RE: ADDENDUM #1
Bid #B171025, CDBG Round 2.2 I-45 Waterline Project

**ADDENDUM NO. 1
TO THE
TECHNICAL SPECIFICATIONS, CONTRACT DOCUMENTS AND PLANS FOR
BID #B171025, CDBG ROUND 2.2: I-45 WATERLINE PROJECT
GLO CONTRACT NO. 13-465-000-7974
PROJECT NO. P21465
GALVESTON COUNTY AND THE TEXAS GENERAL LAND OFFICE**

**ADDENDUM NO. 3
TO THE
TECHNICAL SPECIFICATIONS, CONTRACT DOCUMENTS AND PLANS FOR
BID #B171025, CDBG ROUND 2.2: I-45 WATERLINE PROJECT
GLO CONTRACT NO. 13-465-000-7974
PROJECT NO. P21465
GALVESTON COUNTY AND THE TEXAS GENERAL LAND OFFICE**

**ADDENDUM NO. 4
TO THE
TECHNICAL SPECIFICATIONS, CONTRACT DOCUMENTS AND PLANS FOR
BID #B171025, CDBG ROUND 2.2: I-45 WATERLINE PROJECT
GLO CONTRACT NO. 13-465-000-7974
PROJECT NO. P21465
GALVESTON COUNTY AND THE TEXAS GENERAL LAND OFFICE**

PROJECT: 14602
 DRAWN: J.T.S.
 CHECKED: J.T.S.
 SHEET NO: 5 OF 41

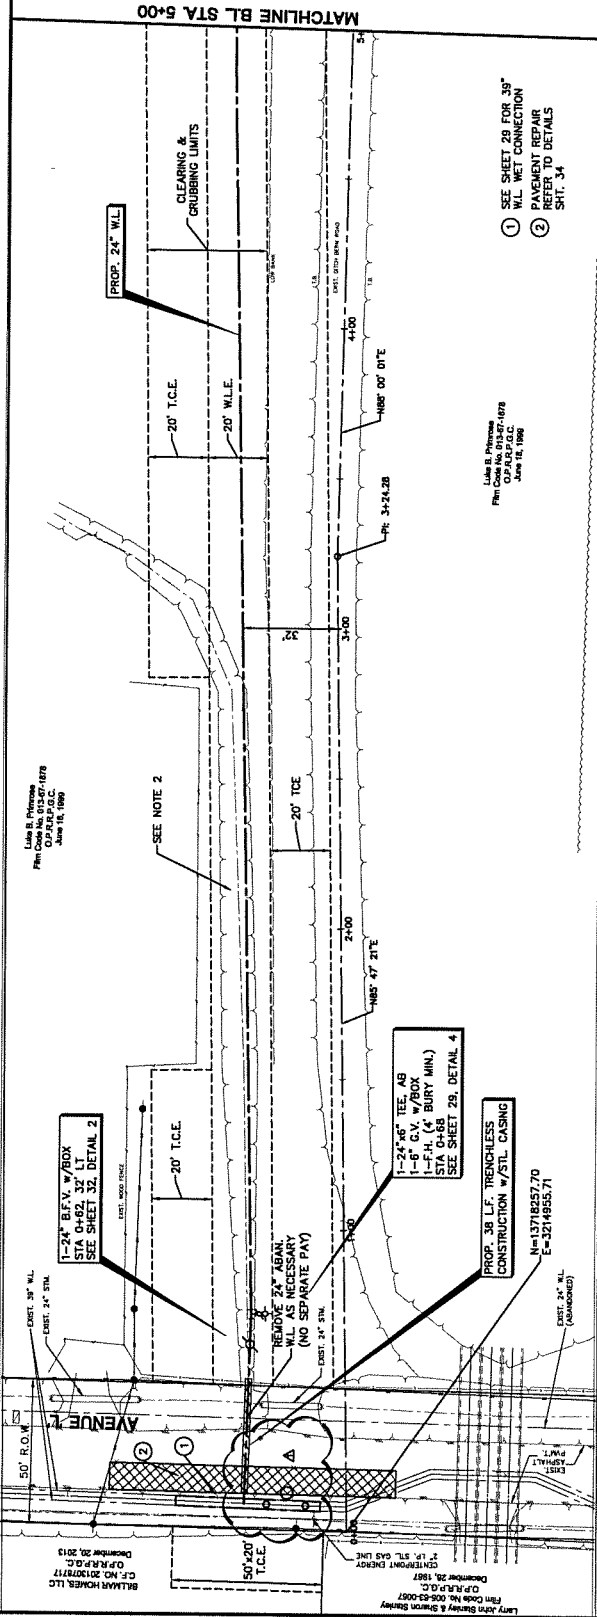
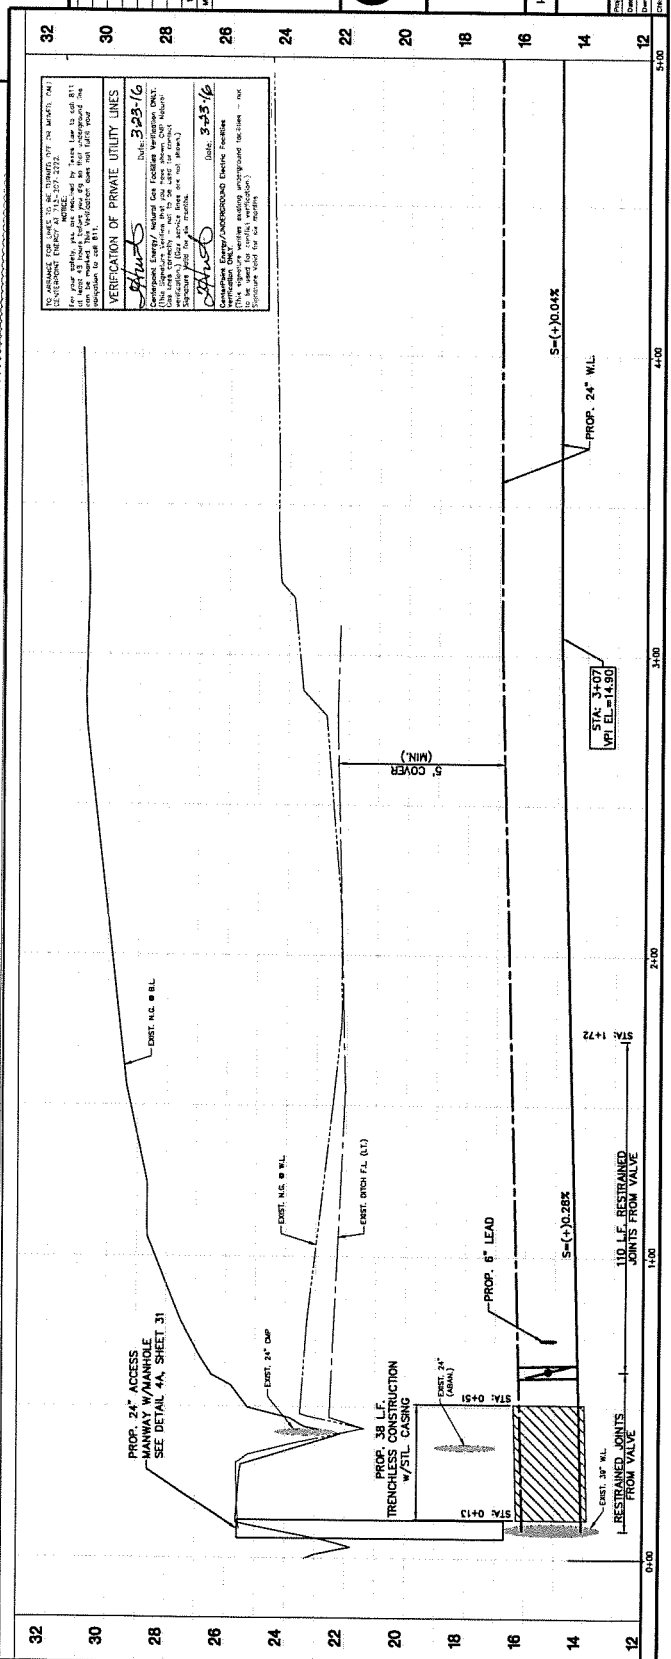
2. Remove Sheet 5 of 41 – 24" Waterline Plan & Profile B.L. STA: 0+00 TO B.L. STA: 5+ and replace with Sheet 5 of 41 – 24" Waterline Plan & Profile B.L. STA: 0+00 TO B.L. STA: 5+ from Addendum No. 3.
3. Remove Sheet 25 of 41 – Flow Control/Pressure Reducing Station Details and replace with Sheet 25 of 41 – Flow Control/Pressure Reducing Station Details from Addendum No. 3.
4. Remove Sheet 26 of 41 – Metering Station Details and replace with Sheet 26 of 41 – Metering Station Details from Addendum No. 3.
5. Remove Sheet 29 of 41 – Water Details and replace with Sheet 29 of 41 – Water Details from Addendum No. 3.
6. Remove Sheet 34 of 41 – Excavation, Bedding, Backfill and Pavement Repair Details and replace with Sheet 34 of 41 – Excavation, Bedding, Backfill and Pavement Repair Details from Addendum No. 3.

PROJECT INFORMATION		SHEET	
PROJECT NO.	146 & 1140-8 WATER DISTRIBUTION SYSTEM	SHEET NO.	29
DATE	SEP 22, 2017	TOTAL SHEETS	41
DESIGNED BY	J.L.S.		
CHECKED BY	J.M.E.

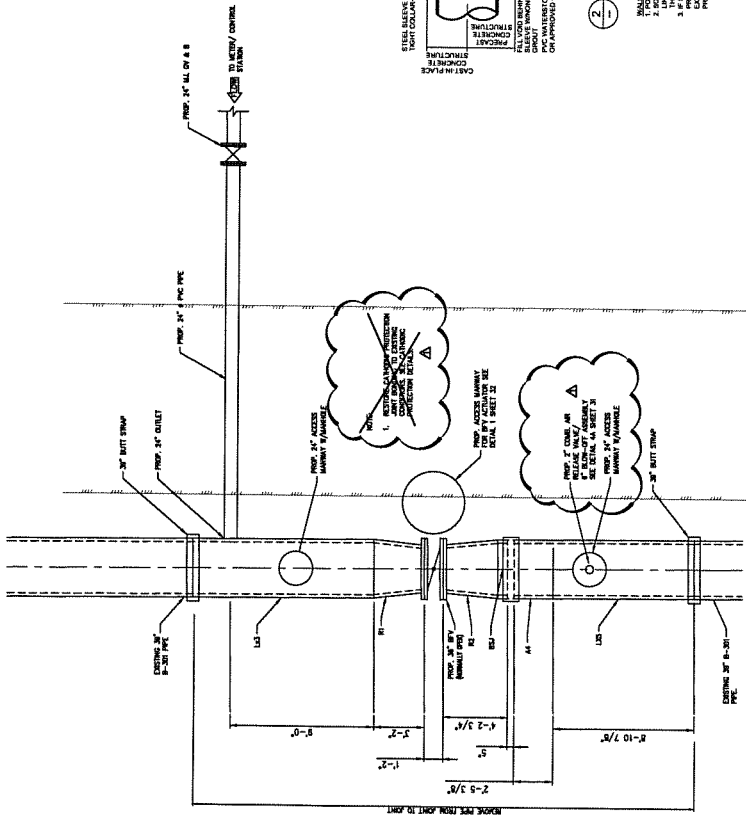
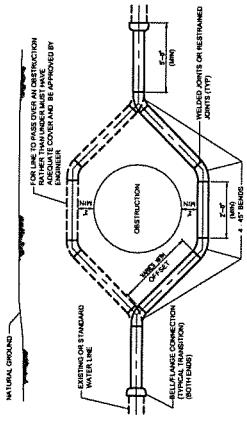
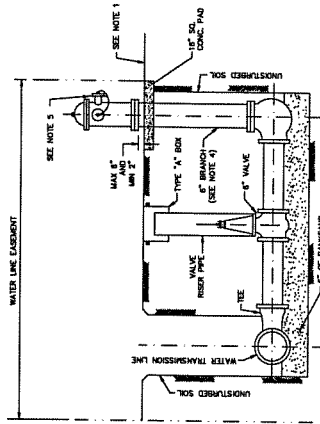
1. **Q:** Please confirm existing 39" Pipe Type, either AWWA C301 PCCP Lined Cylinder Pipe, or AWWA C303 Bar Wrapped Cylinder Pipe. Drawing 29 states pipe is "B-301". Specification summary of work page 7 of 8 says to use PCCP for construction. If existing is PCCP, connections must be completed at the joints. If the existing pipe is Bar Wrap, connections can be made using welded butt strap closures (refer to drawing 29).
